PLANS FOR CONSTRUCTION ON  
 STATE HIGHWAY  
 IN RIVERSIDE COUNTY IN RIVERSIDE ON MULBERRY STREET  
 AT SEVENTH STREET AND AT EIGHTH STREET

VIII-Riv-19-Riv  
**MODIFY TRAFFIC SIGNALS AND  
 CONSTRUCT CHANNELIZATION**  
 IN RIVERSIDE ON MULBERRY STREET AT  
 SEVENTH STREET AND AT EIGHTH STREET  
 SCALE-AS SHOWN

TRAFFIC SIGNAL MODIFICATIONS  
**UNIVERSITY AVENUE  
 AND  
 MULBERRY STREET**

<b>CITY OF RIVERSIDE</b> <b>PUBLIC WORKS DEPARTMENT</b>		<b>TRAFFIC SIGNAL REVISIONS</b> <b>UNIVERSITY AVENUE</b> <b>REDWOOD DR TO KANSAS AVE.</b> <b>UNIVERSITY AVE &amp; MULBERRY ST.</b>		ACCOUNT NO. 30-575-245-07 <b>X-142</b> SHEET ____ OF ____
APPROVED BY PRINCIPAL ENGINEER PARK DEPARTMENT TRAFFIC DIVISION CHIEF P.W. ENGINEER TELECOMMUNITIES	DATE 5/12/80 2:22 PM	APPROVED BY William S. Gardner PUBLIC WORKS DIRECTOR	DATE 5-30-80	HORIZ. SCALE: 1"=20' VERT. SCALE: 1"=

For legend see SPECIAL DETAILS sheet  
 SIGNAL PLAN  
 Scale: 1"=20'

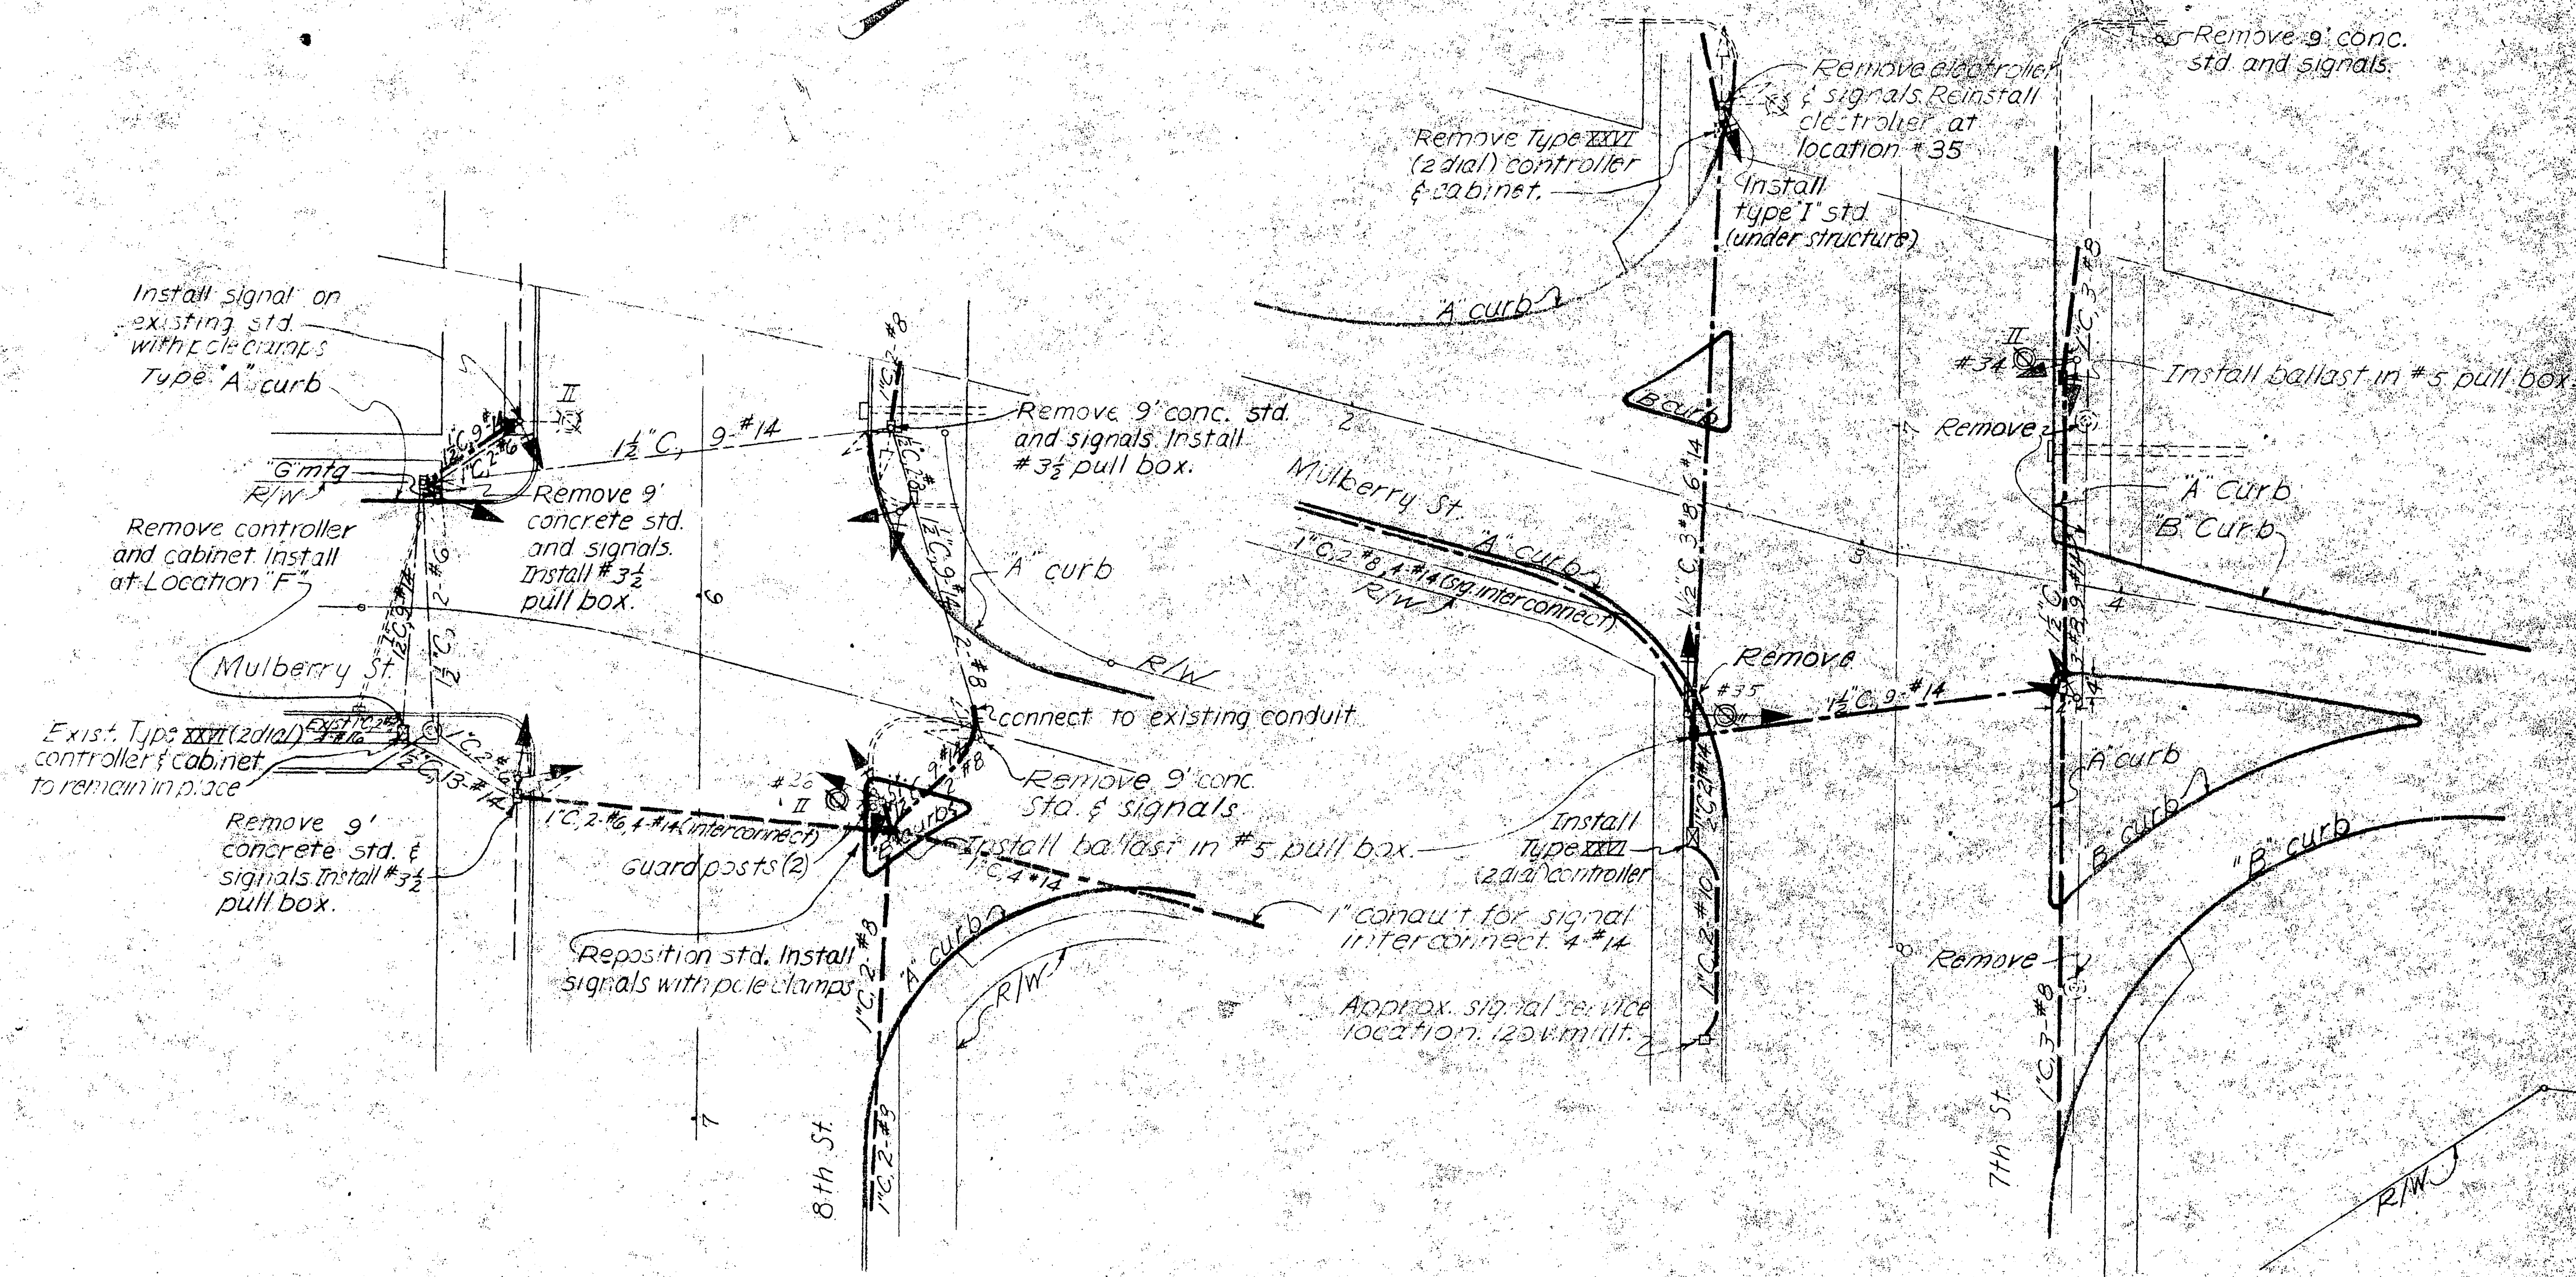
Remove electroler & signals. Reinstall electroler at location #34  
 Remove 9' conc. std. and signals  
 Existing Mulberry St. intersection

AS BUILT  
 CORRECTIONS BY J. McDonald  
 DATE 9/30/57  
 7th St. & MULBERRY  
 LOCATION "I"

- Notes: Locations 'G' and 'I'
1. Remove and salvage signals and 9' concrete standards. Reinstall at locations on Lime St. as required.
  2. Reposition lighting standards as shown.
  3. All signals, mounting brackets, type 'I' standards, and wiring at locations 'G' & 'I' shall be new.

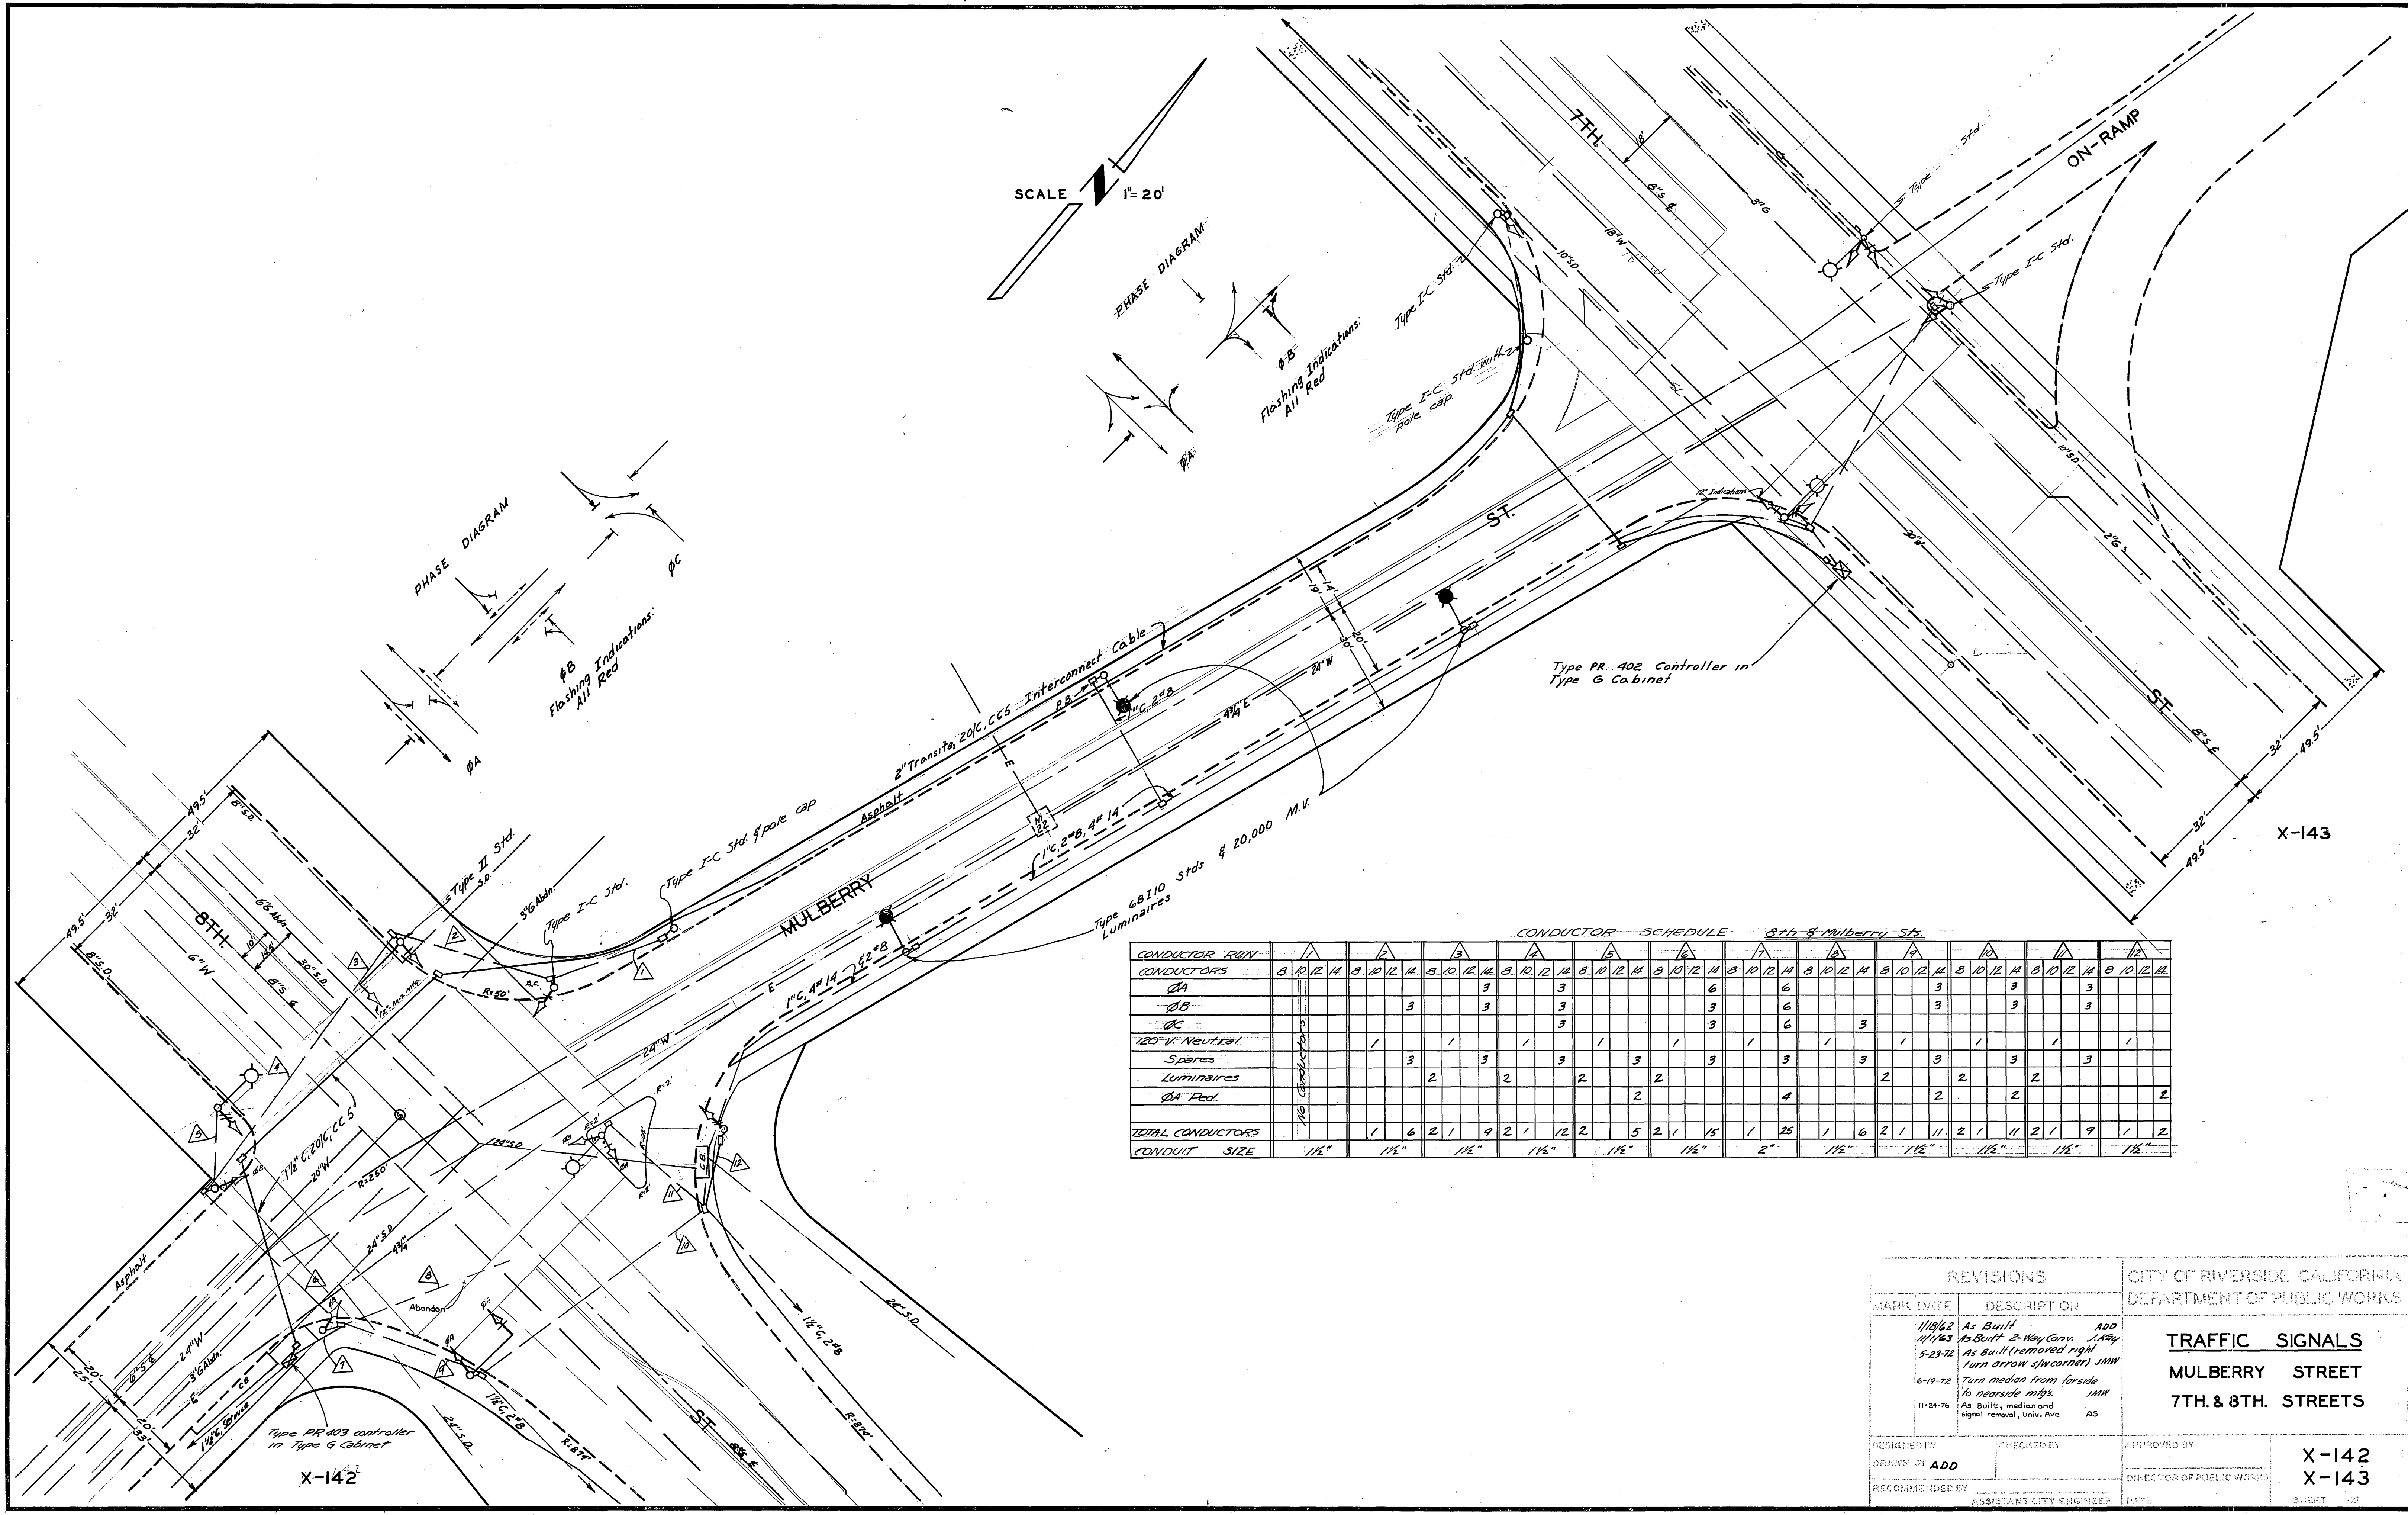
REVISIONS			CITY OF RIVERSIDE CALIFORNIA DEPARTMENT OF PUBLIC WORKS
MARK	DATE	DESCRIPTION	
	1/18/62	As Built	<b>TRAFFIC SIGNALS</b> <b>MULBERRY STREET</b> <b>7TH. &amp; 8TH. STREETS</b>
	1/1/63	As Built - 2-Way Conv. JAW	
	5-23-72	As Built (removed right turn arrow sign/corner) JMW	
	6-19-72	Turn median from far side to nearside m/bk. JMW	
	11-24-76	As Built, median and signal removal, Univ. Ave AS	
DESIGNED BY	CHECKED BY	APPROVED BY	X-142
DRAWN BY ADD		DIRECTOR OF PUBLIC WORKS	X-143
RECOMMENDED BY	ASSISTANT CITY ENGINEER	DATE	SHEET OF
